NOTICE OF ADDENDUM

ADDENDUM NO. 1

CONTRACT NO. 6457, Project 53W1393
Madison Police Department Training Center – Phase 3

X:\46453\cad\46453dcSKA01.dgn

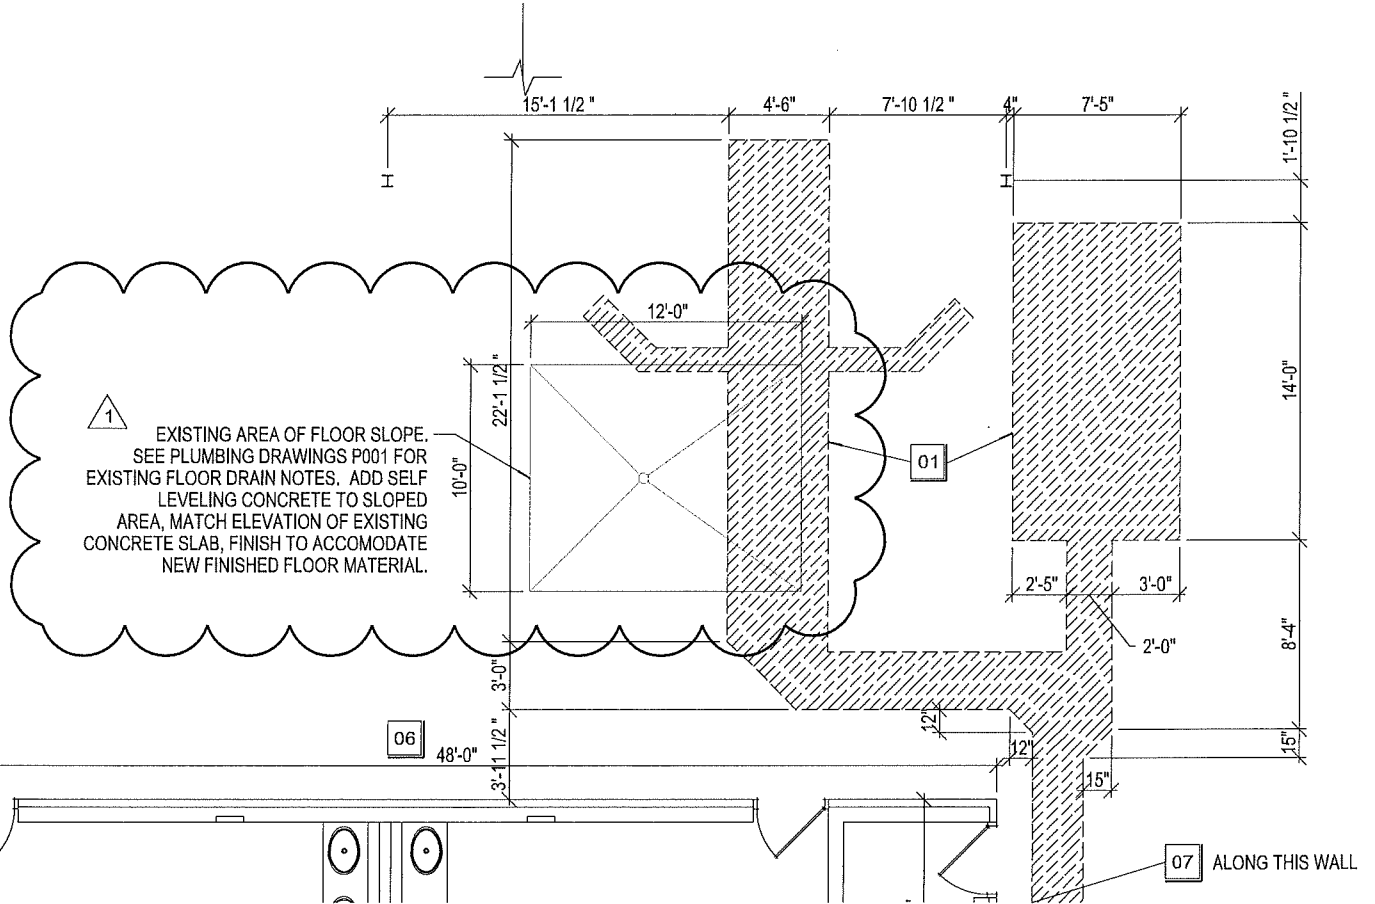
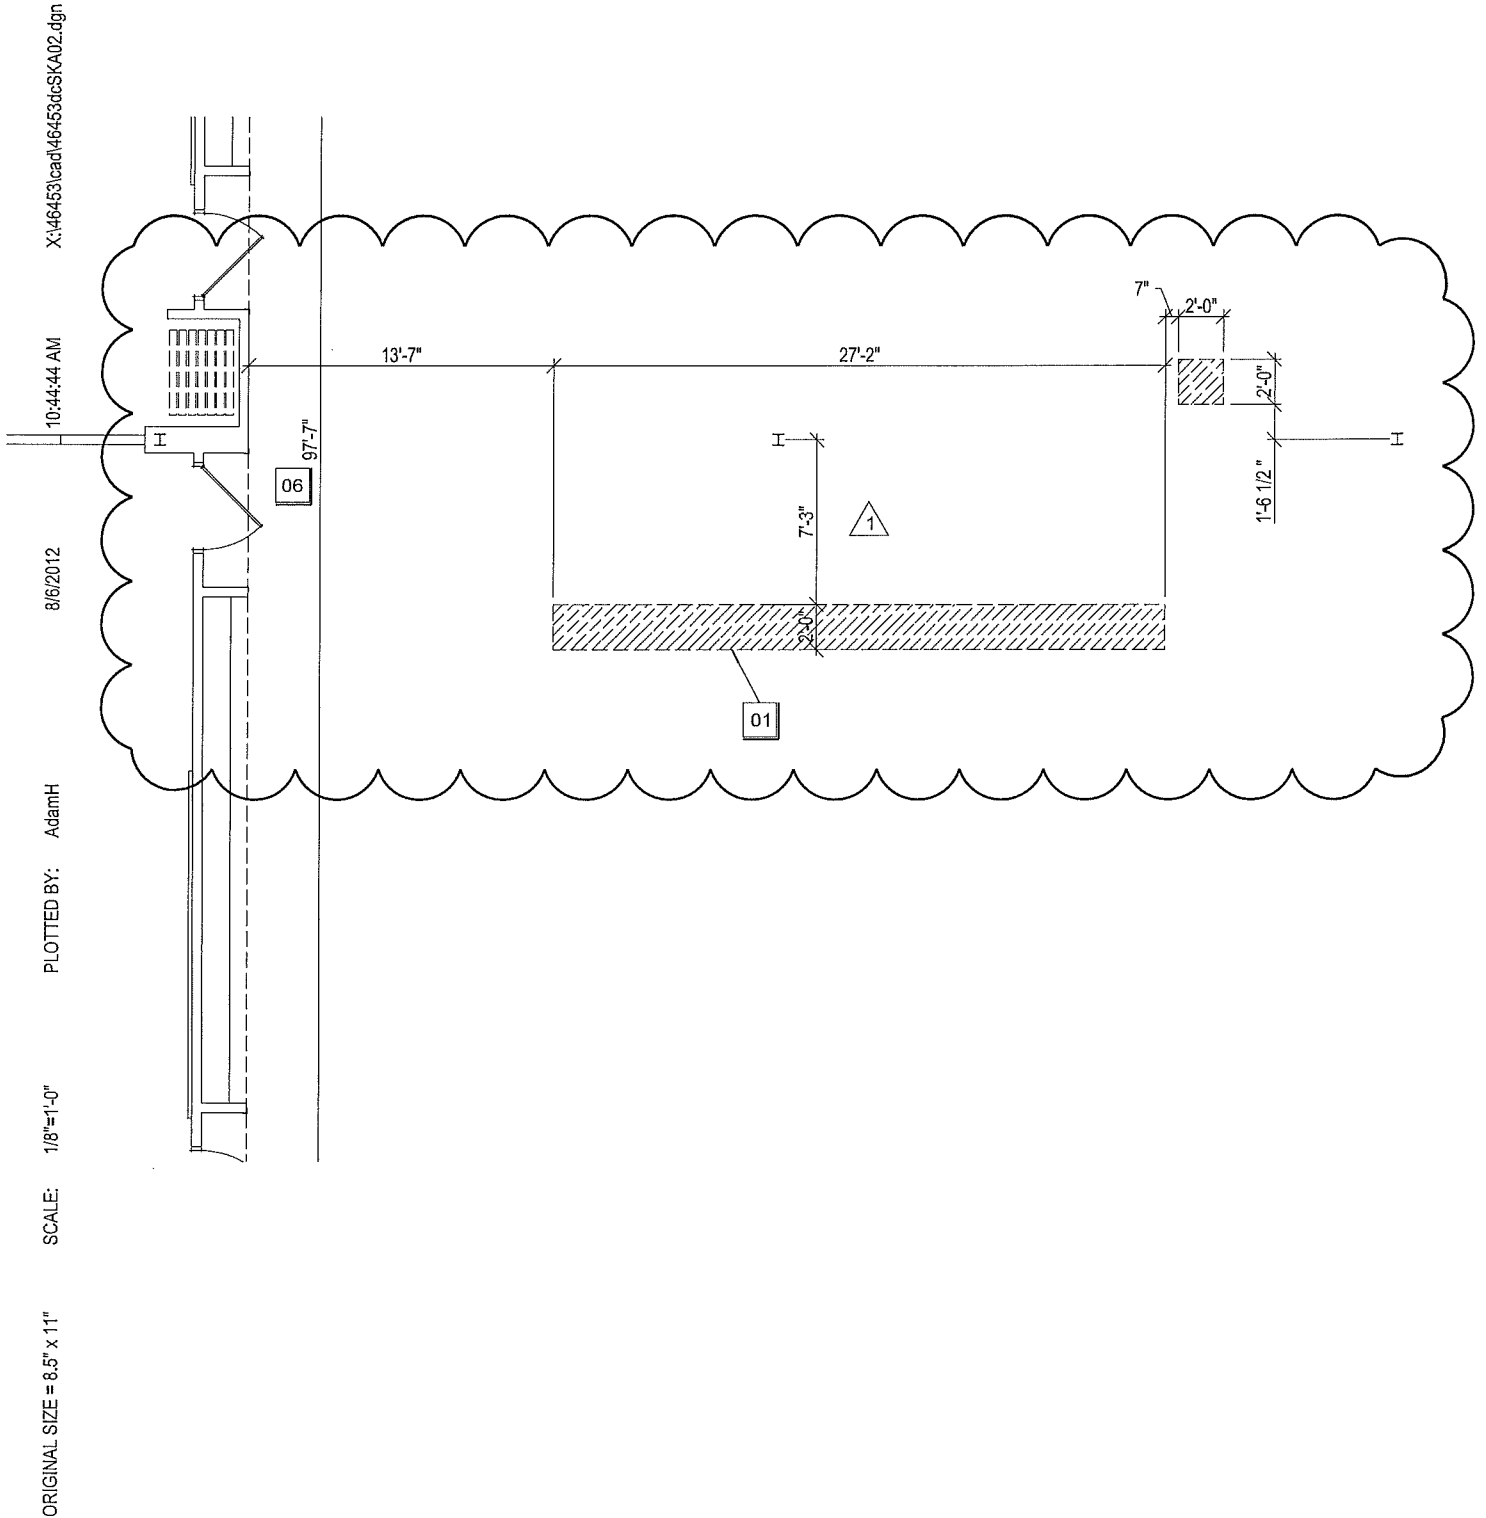
1. See attached sketch SKA01 for additional floor plan note.
2. Add General Note 1 that GC shall properly dispose of (2) previously removed 8' x 8' overhead doors including door panels, track, motors, springs, and push button controls.

X:\46453\cad\46453dc\SKS01.dgn

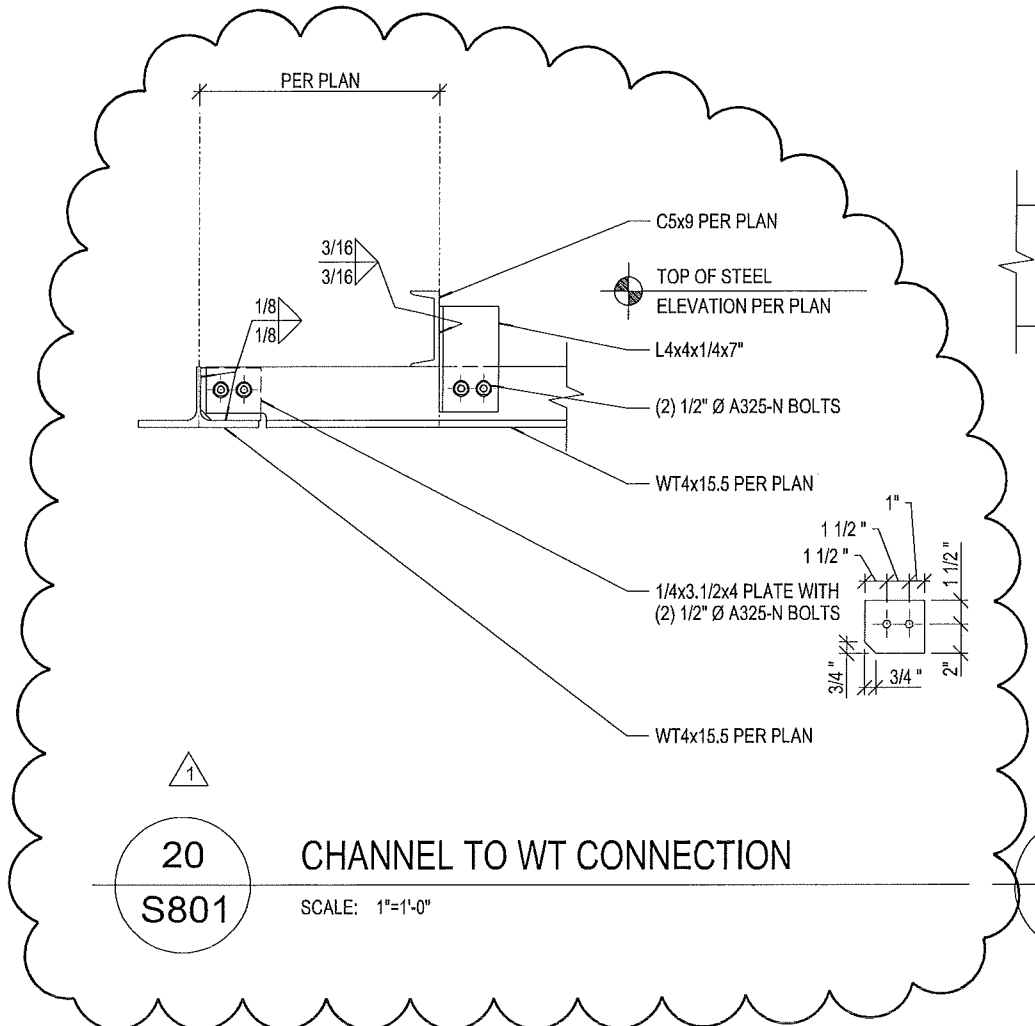
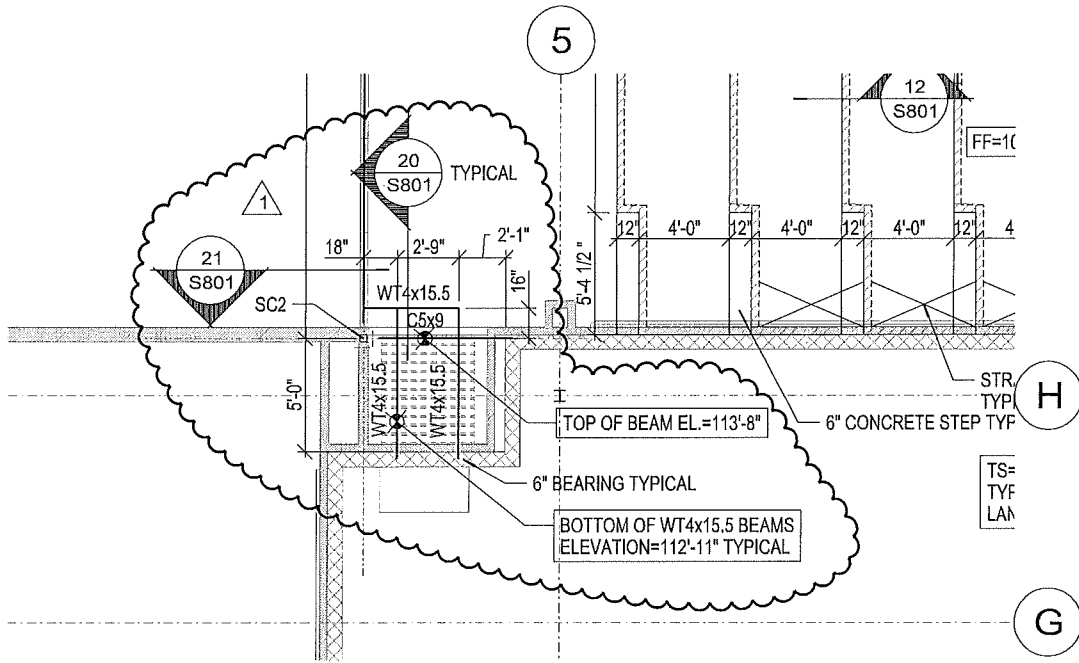
1. See attached sketch SKS01 and SKS02 for revised framing plan.

X:\46453\cad\46453.dwg

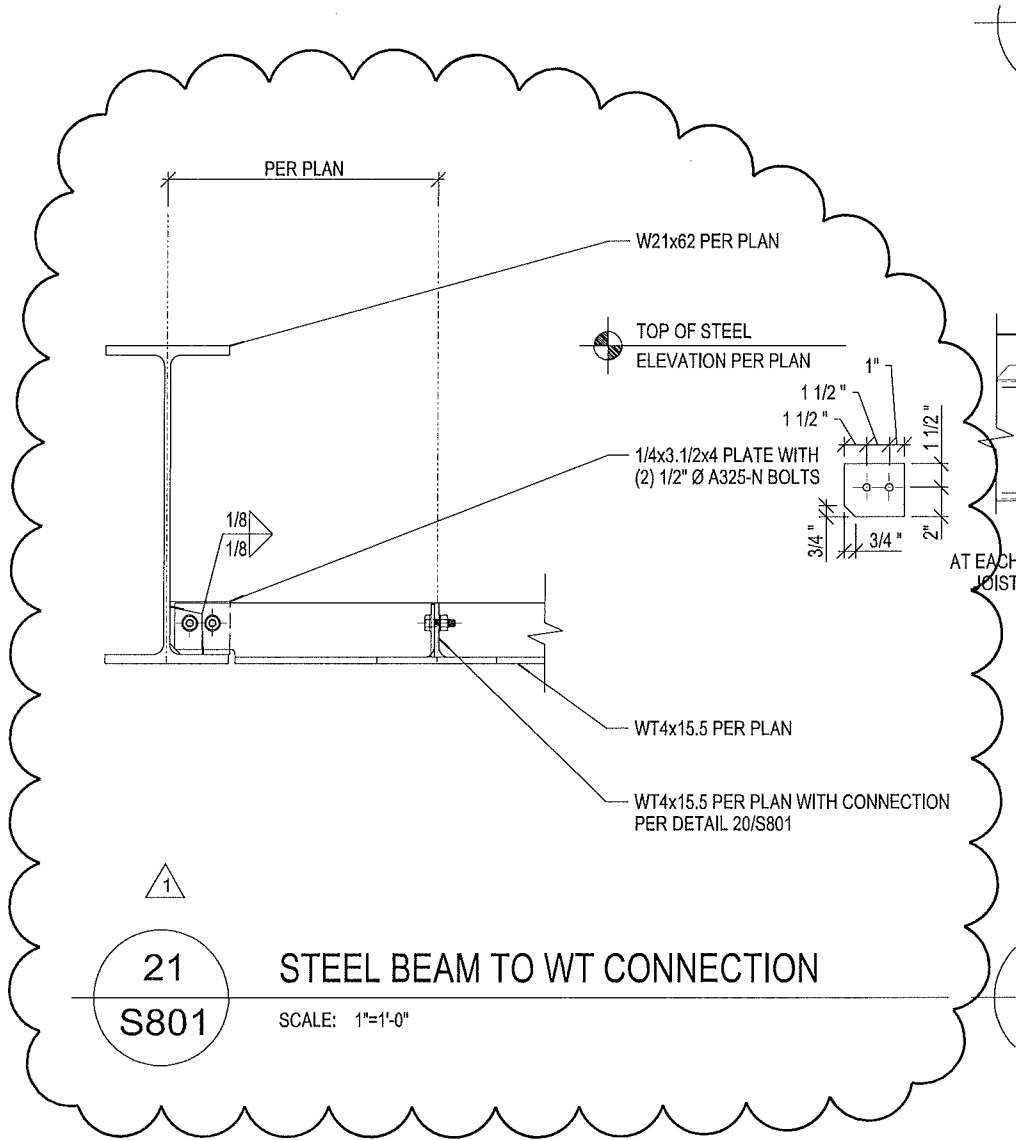
4. At Partial Existing Floor Plan, omit vinyl wall base in Staging Area 137.
5. See attached sketch SKA02 for saw cut change in Computer Lab 116 to extend to the North wall in lieu of the South wall.
